RECREATIONAL VEHICLE SERVICE CAMPAIGN

Service Advisory: 21-415

SERVICE ADVISORY # 21-415

Arcadia A/C Ducts & Wiring

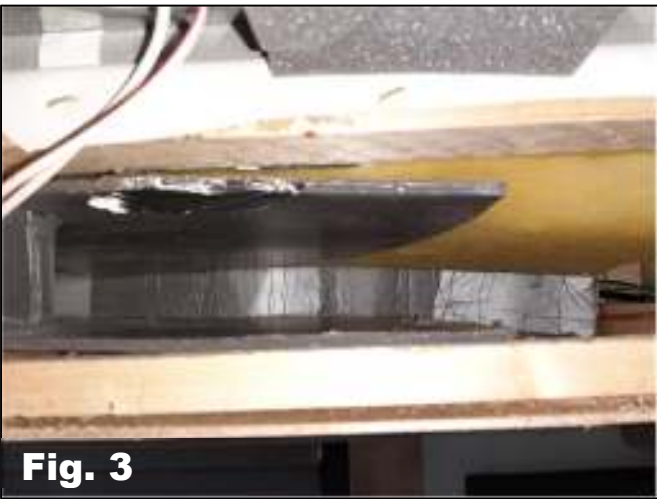
Remove the Chillgrille, divider, and clamp ring. See Figure 2.
